CHAPTER 3

Comments and Responses

3.1 Comments on the Draft EIR and Responses

This section contains all comment letters and responses to comments. Each comment letter is assigned an alphanumeric code, from A1 through C40, and each comment is numbered in the margin of the comment letter. Responses to the comments follow each letter, and responses are referenced using the same alphanumeric system. For example, the first comment from the first letter, from the National Oceanic and Atmospheric Administration, is designated A1-1, as is the response to it. Testimony from the public hearing is assigned the code “PH” and follows the comment letters.

Figure 4.5-5
Critical Habitat in the Vicinity of the Project Sites

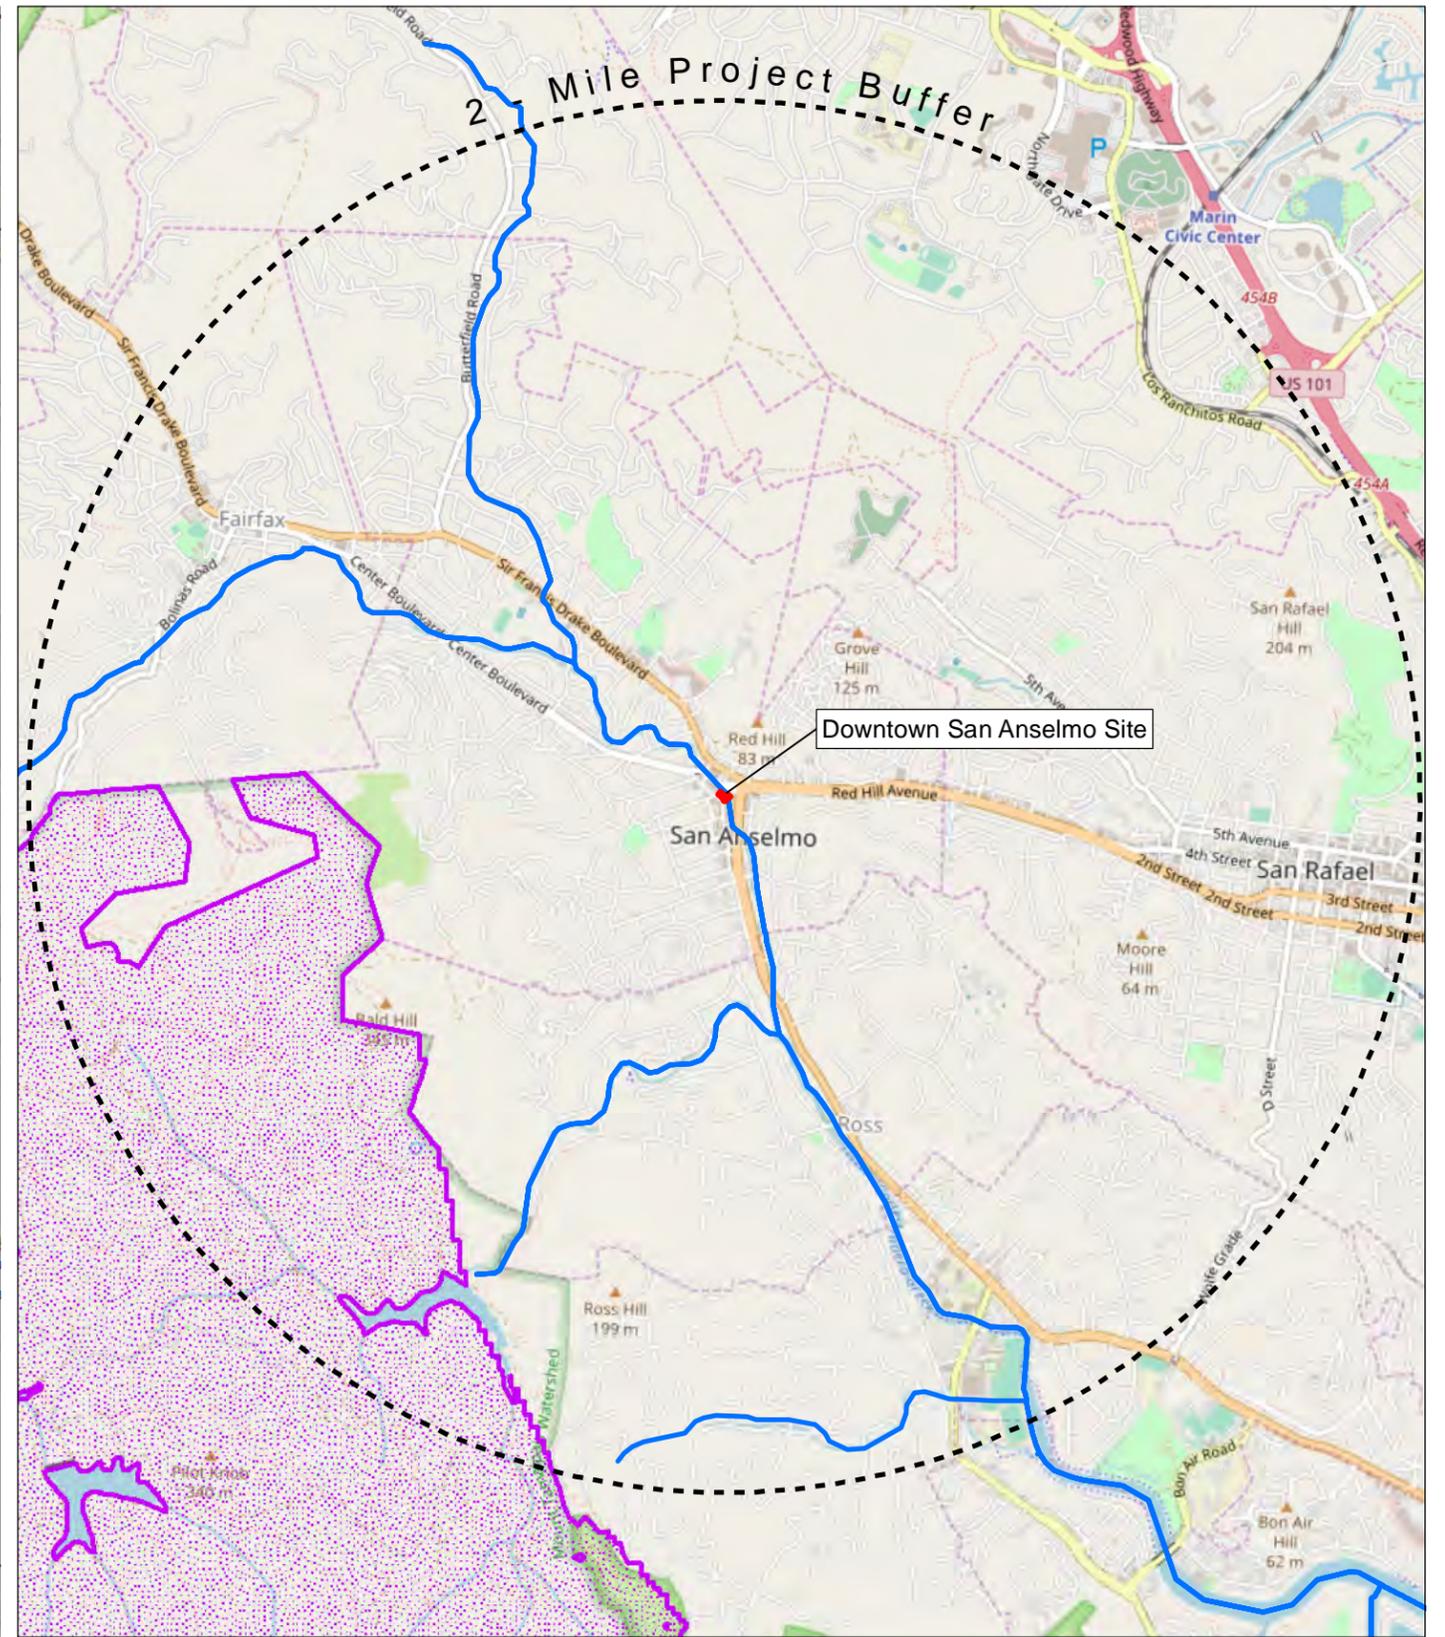
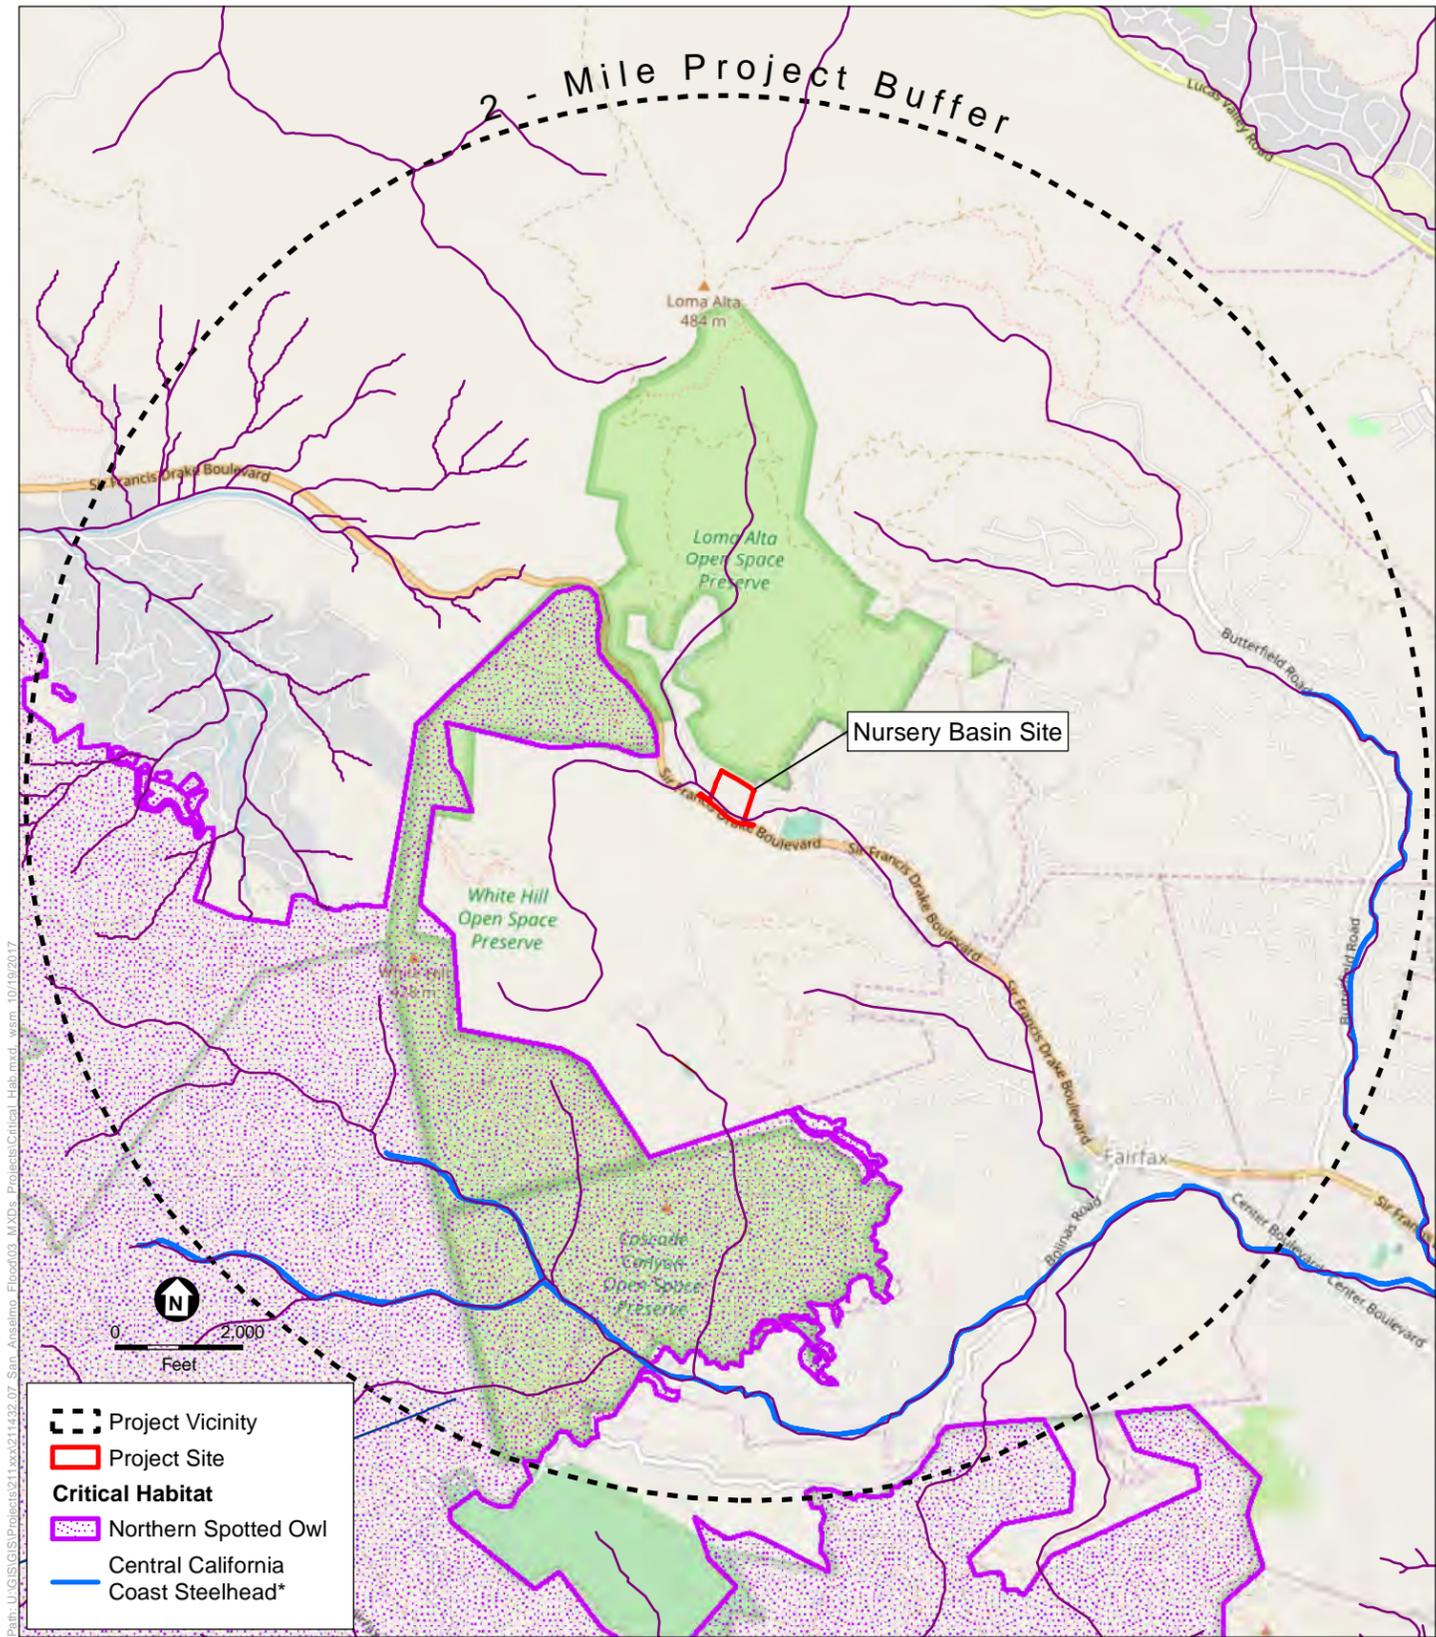
The mouth of Tamalpais Creek is not accurately depicted on Figure 4.5-5. Tamalpais Creek enters a culvert at Kent Avenue and joins Corte Madera Creek just downstream of the concrete channel. The relict mouth located near College of Marin Parking Lot 13 is no longer connected to Tamalpais Creek.

- B1-6 This comment suggests a correction to the portrayal of a portion of Tamalpais Creek on Draft EIR Figure 4.5-5.

Draft EIR Figure 4.5-5 has been revised in response to this comment. The data source was the U.S. Fish and Wildlife Service, however, not original work done for this comment. The referenced creek is far downstream from the project area in downtown San Anselmo.

In response to Comment B1-6, the portrayal of Tamalpais Creek on Draft EIR Figure 4.5-5 (page 4.5-21) has been revised, as shown below.
